#tnl2016-0015e # 1 / 3

DFD6361 Half-cut Specification Machine Directive (CE Marking) Specification Instruction Manual Request to Correct Errors Regarding Cover Configuration and Safety Switch Position

Request for verification and correction

Error detail 1: error relating to cover configuration

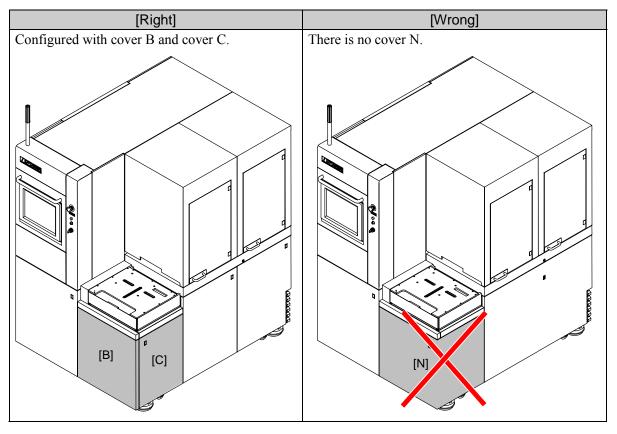
For the CE marking-adapted machine, the manual indicated that there was a single-cover configuration (cover N) combining cover B and cover C, but this is an error. The covers are the same as the standard machine.

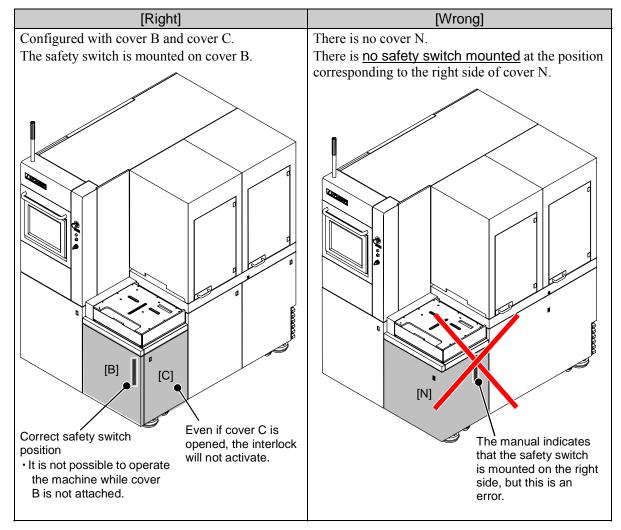
Error detail 2: error relating to safety switch position

The manual indicates that the safety switch is mounted on the right side of cover N, but this is an error. The safety switch is mounted on cover B (front of machine). There is no safety switch mounted on cover C (right side of machine).

The interlock will not activate even if cover C is opened.

It is not possible to operate the machine while cover B is not attached.

When cover B is opened, the interlock will activate.

Feature 7: Change in the Configuration of the Outer Cover

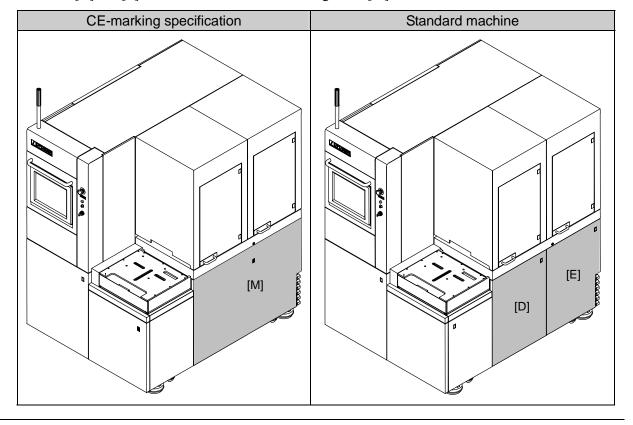
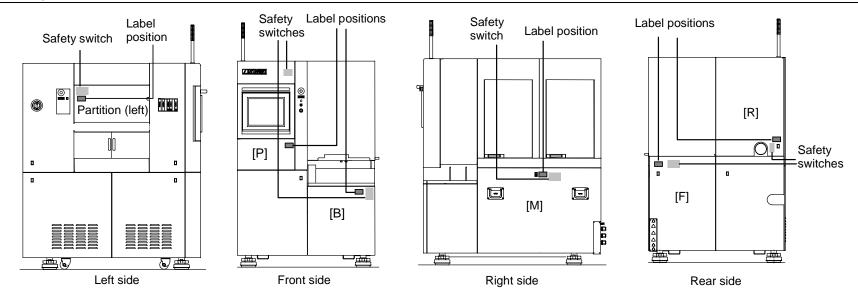
The configuration of the outer covers has been changed as shown below for CE marking specification.

• Covers [D] and [E] have been integrated together and changed in order to comprise 1 cover (cover [M]).

• Covers [D] and [E] should be understood as meaning cover [M].

Interlock devices of the machine outer cover (The machine outer cover (partition (left), [P], [B], [M]and [R] cover) labeled with is equipped with interlock devices.)
